October 3, 1986

Docket No. 50-336
B12275
A05935

Millstone Nuclear Power Station, Unit No. 2
Storage of Consolidated Spent Fuel

Figure 1

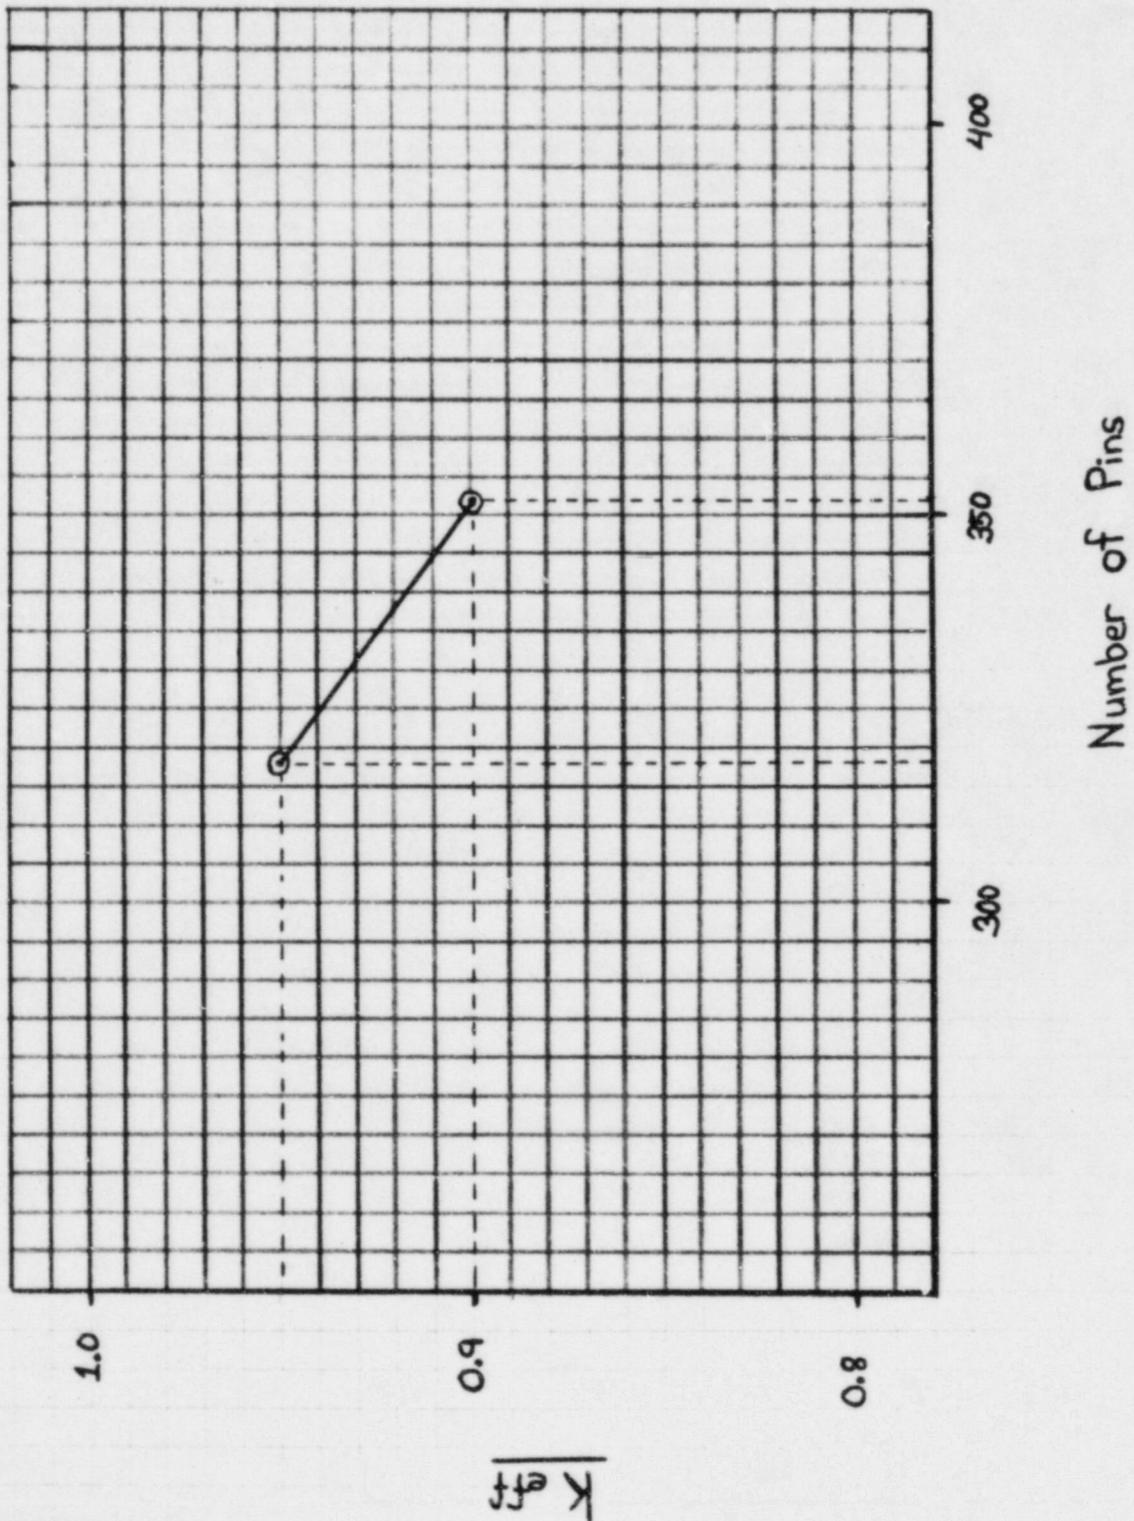
How is the reactivity effect of less than a full consolidated storage box (less than 352 rods) accounted for?

The consolidation process permits the placement of solid metal rods in positions where fuel rods are missing. For those instances where solid rods are not used, a limited number of fuel rods can be omitted based on the attached Figure 1. Using Figure 1, the reactivity effect of less than a full consolidated storage box can be established by determining the maximum number of fuel rods that can be omitted while maintaining K-eff at 0.95 or less.
